Project No. 07516-42-02
February 9, 2022

Subject: ADDENDUM GEOTECHNICAL REPORT AND
RESPONSE TO CITY OF SAN DIEGO REVIEW COMMENTS
NAKANO
SAN DIEGO, CALIFORNIA

GEOLOGIC MAP
NAKANO
CHULA VISTA, CALIFORNIA

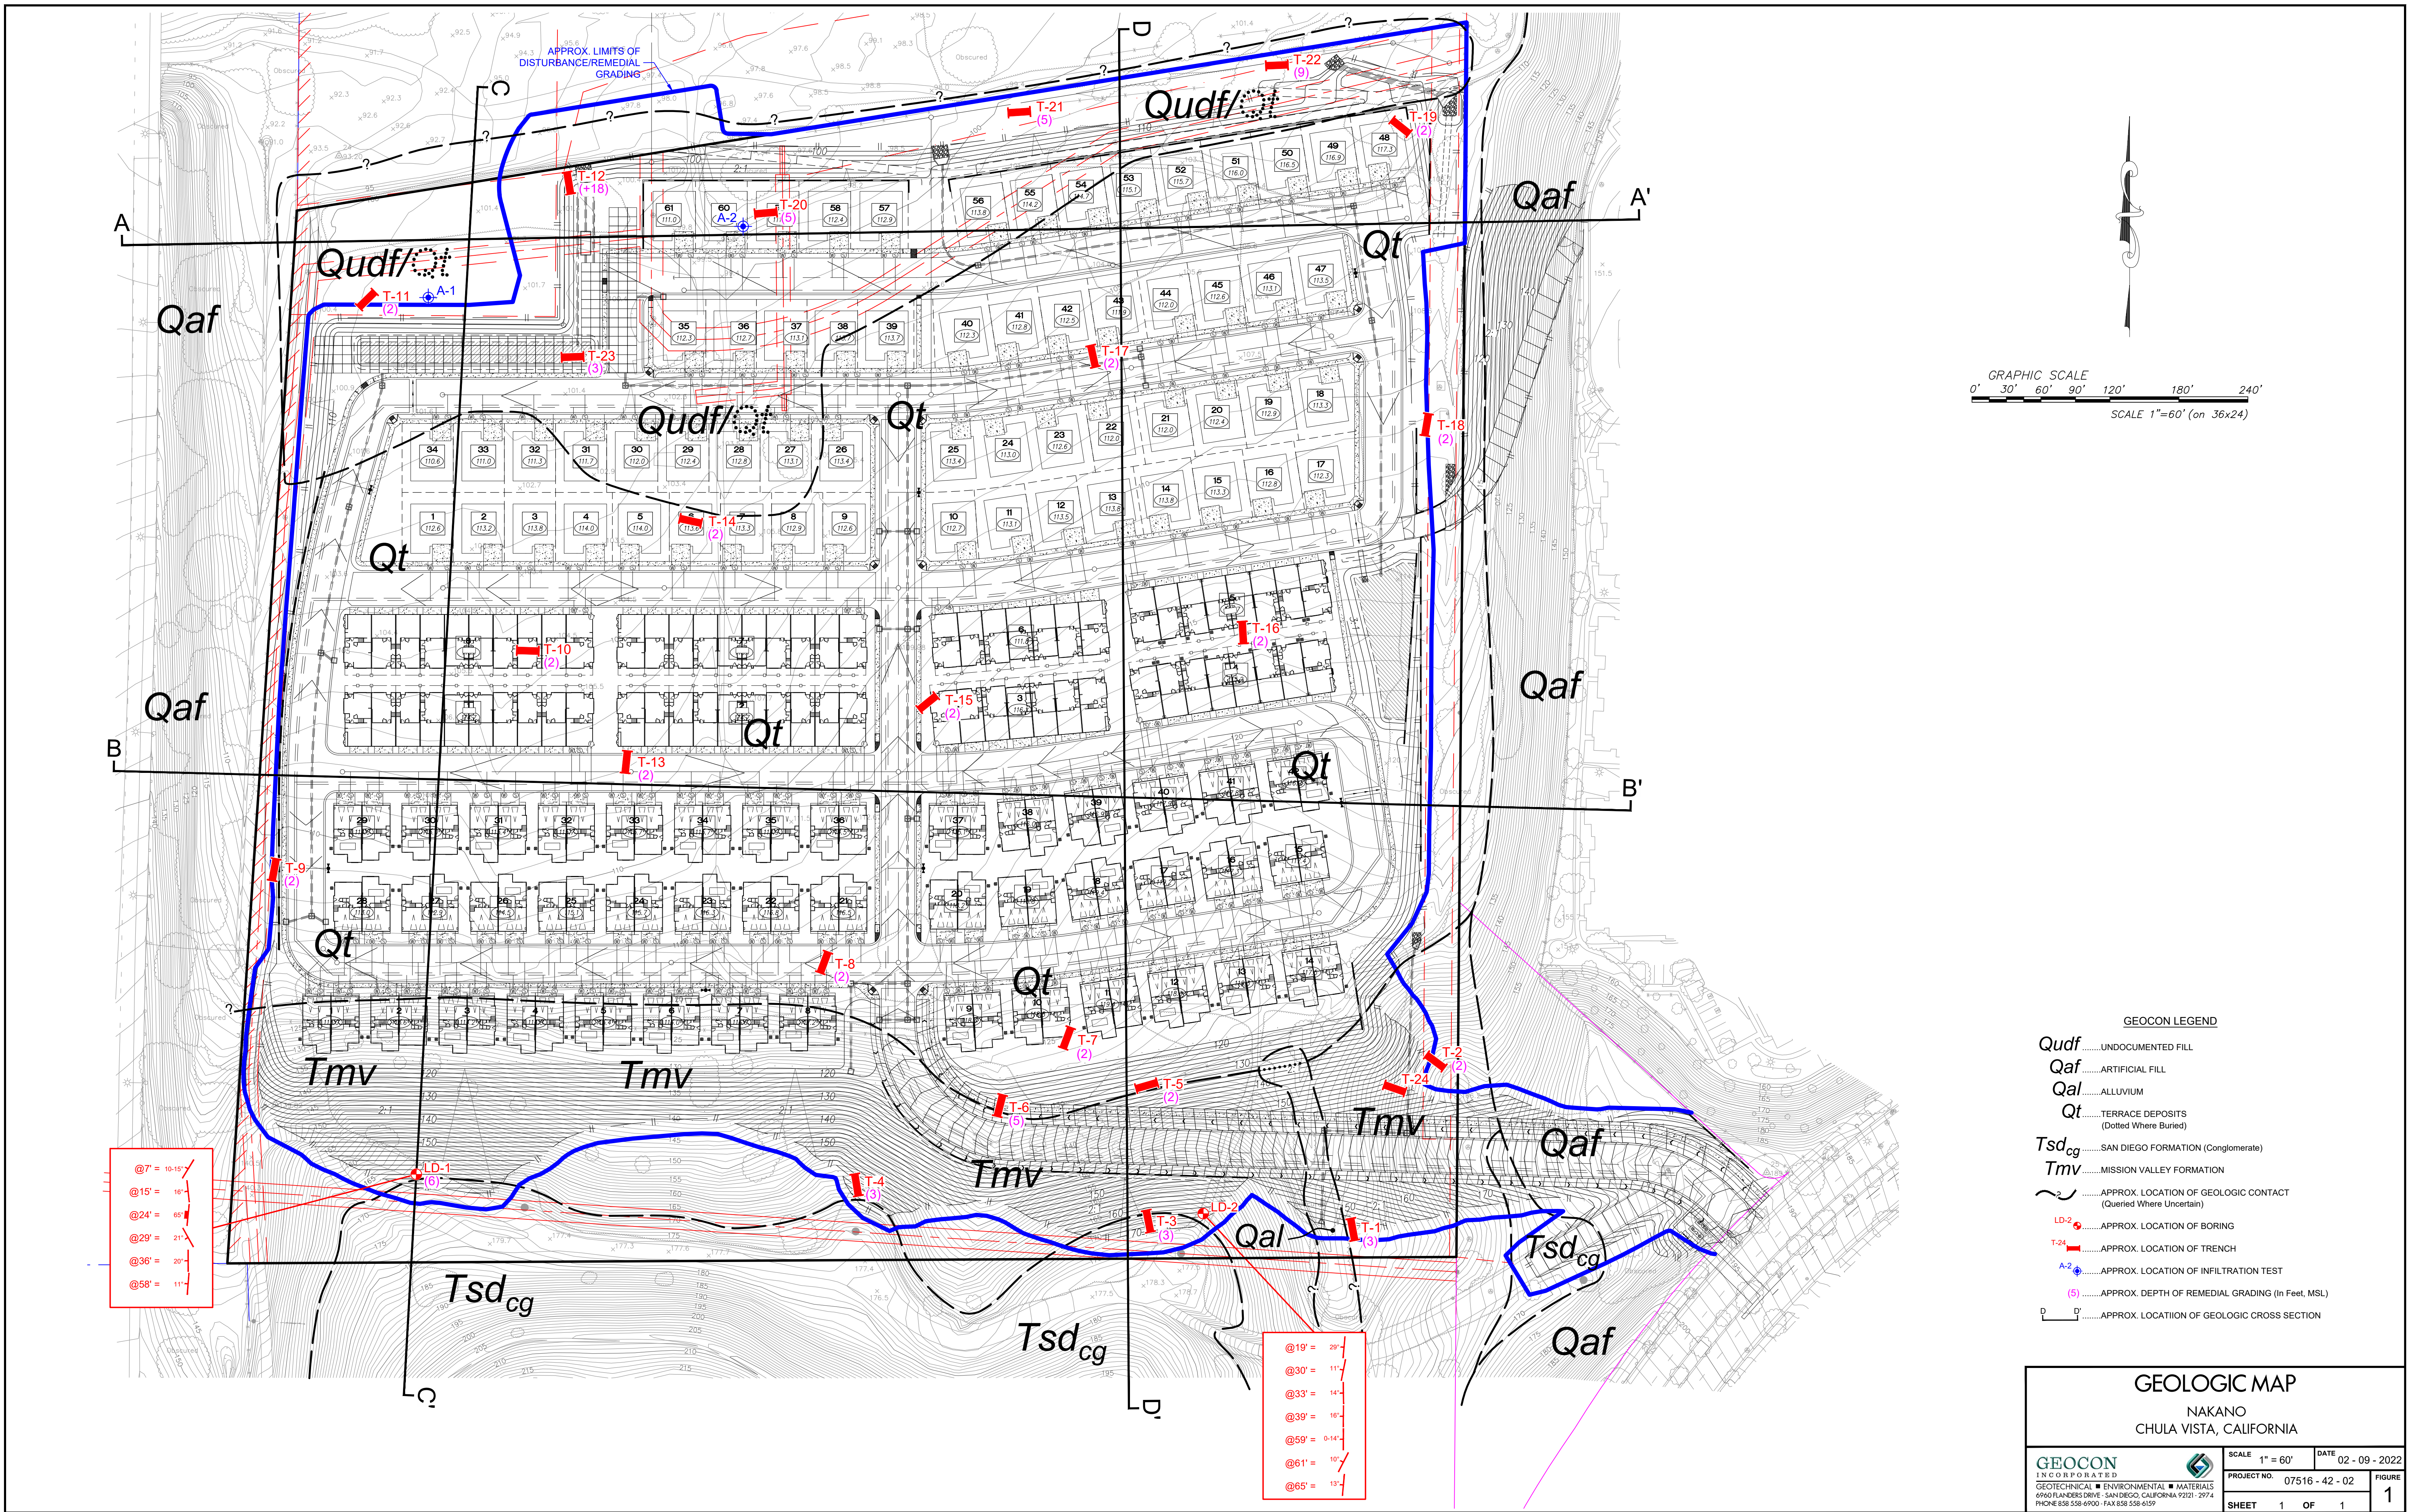
Issue 4: *Clarify if the southeastern corner of the subject property is underlain by a landslide (geologic hazard zone 22) with a rupture surface deeper than the extent explored in the test pits.*

Response: The southeast corner of the property is not underlain by a landslide. A second large diameter boring (LD-2) was drilled to a depth of 70 feet at the east end of the proposed cut slope (Figure 1 and appended boring log). The boring bottom elevation is approximately 16 feet below proposed pad grade at toe of slope. Observations made during downhole logging show similar geologic conditions to those observed in LD-1, i.e., a massive to poorly bedded very fine-grained silty sandstone dipping approximately 14 degrees due west. There are no slide planes, bedding plane shears, or other geologic features indicative of landsliding present in LD-1 or LD-2.

GEOLOGIC CROSS-SECTION C-C'
SCALE: 1" = 60' (Vert. = Horiz.)

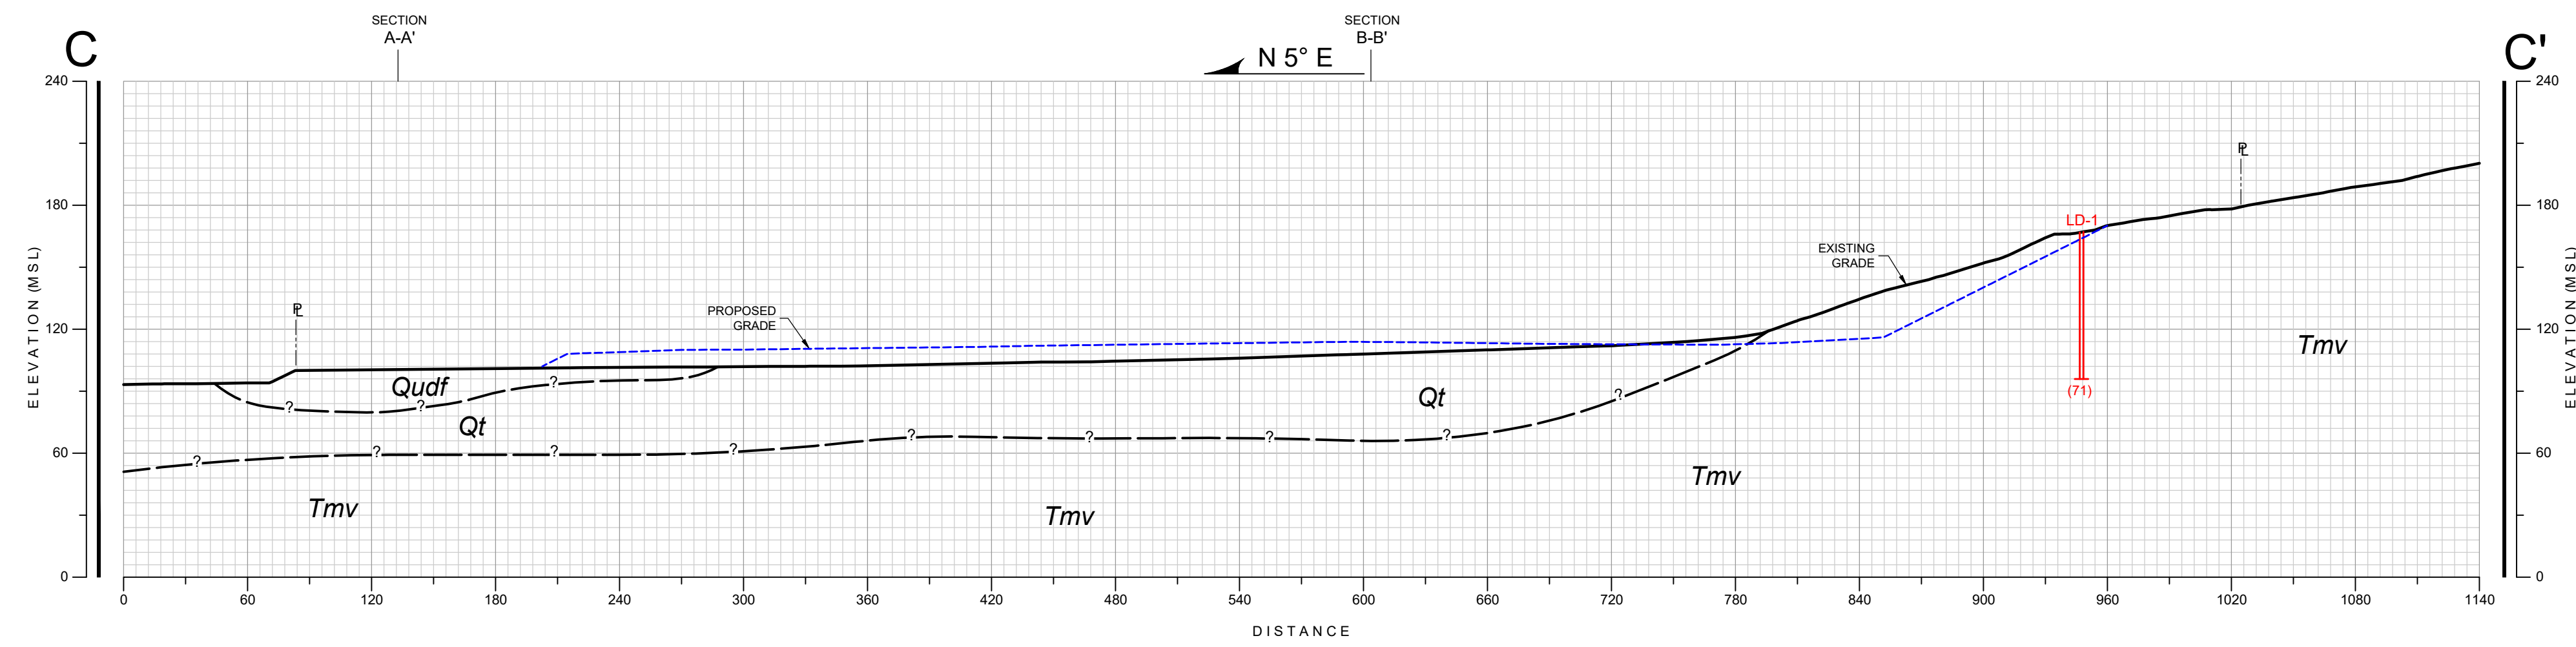
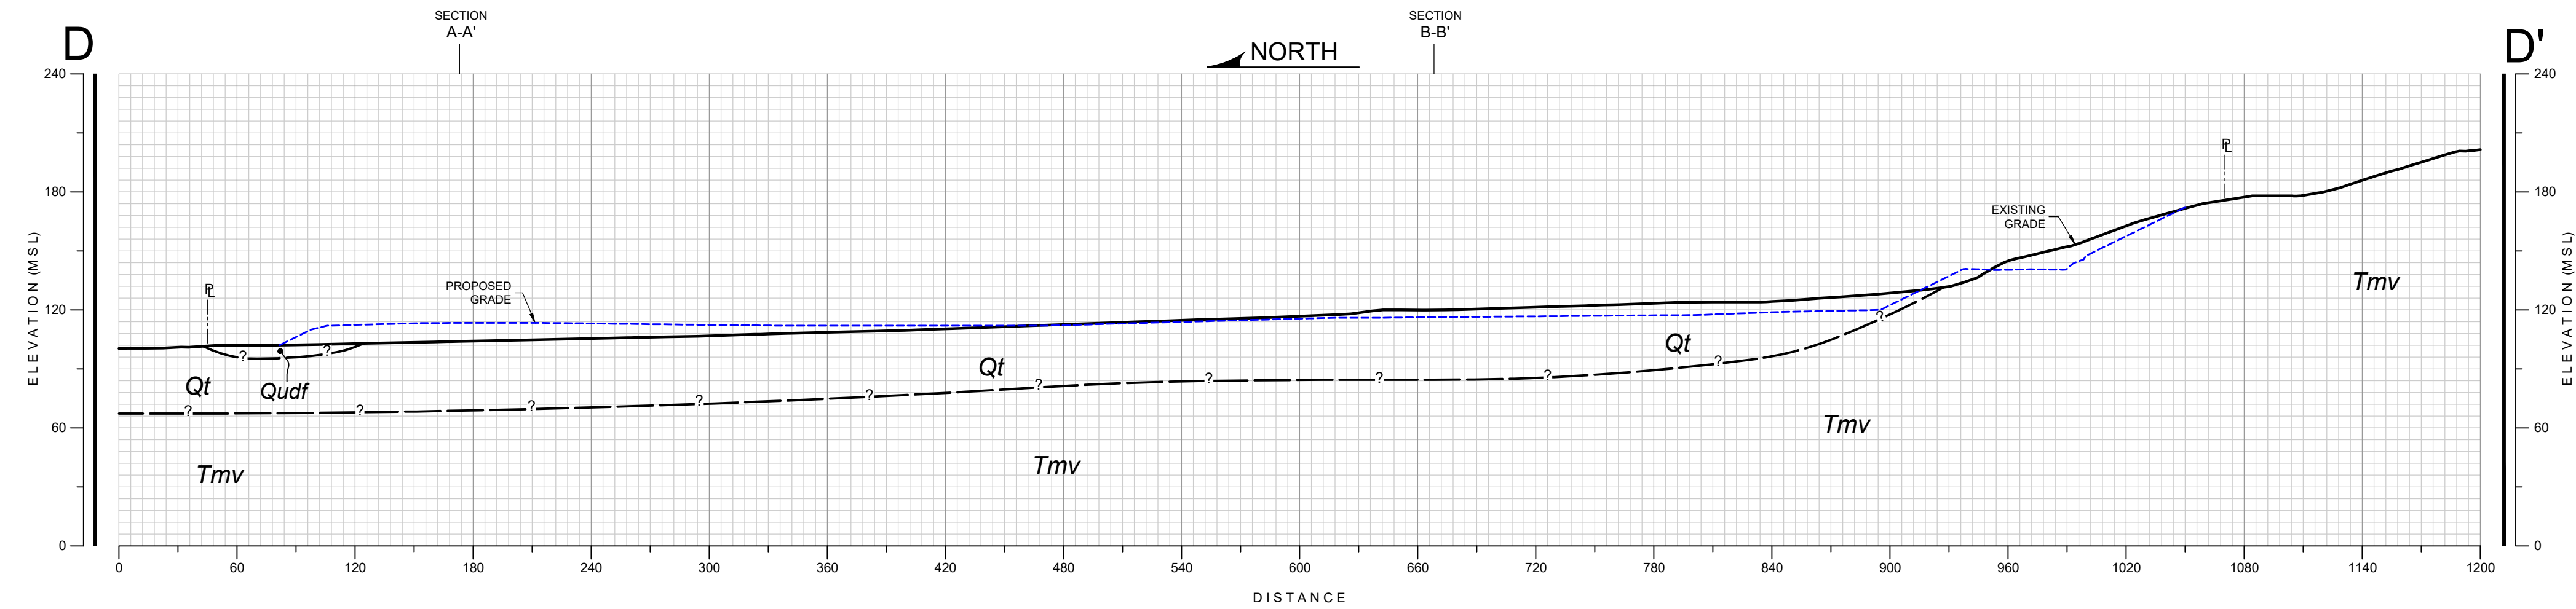
Issue 5: *Per the State's Guidelines for Evaluating Seismic Hazards in California (2008), the commonly accepted factor of safety for slopes is >1.1 for dynamic loads. The projects' geotechnical consultant should demonstrate that the site will comply with this standard following project completion.*

Response: We performed a seismic slope stability analysis for cross sections C-C' and D-D' in accordance with *Recommended Procedures for Implementation of DMG Special Publication 117: Guidelines for Analyzing and Mitigating Landslide Hazards in California*, prepared by the Southern California Earthquake Center (SCEC), dated June 2002.

Using the parameters discussed herein, an equivalent site acceleration, k_{EQ} , of approximately 0.1g was calculated (see Figure 4). Using this k_{EQ} , we get a factor of safety of 1.86 for Section C-C' (see Figure 5) and 2.2 for Section D-D' (see Figure 6). A slope is considered acceptable by the screening analysis if the calculated factor of safety is greater than 1.0 using k_{EQ} ; therefore, the slopes pass the screening analysis for seismic slope stability.
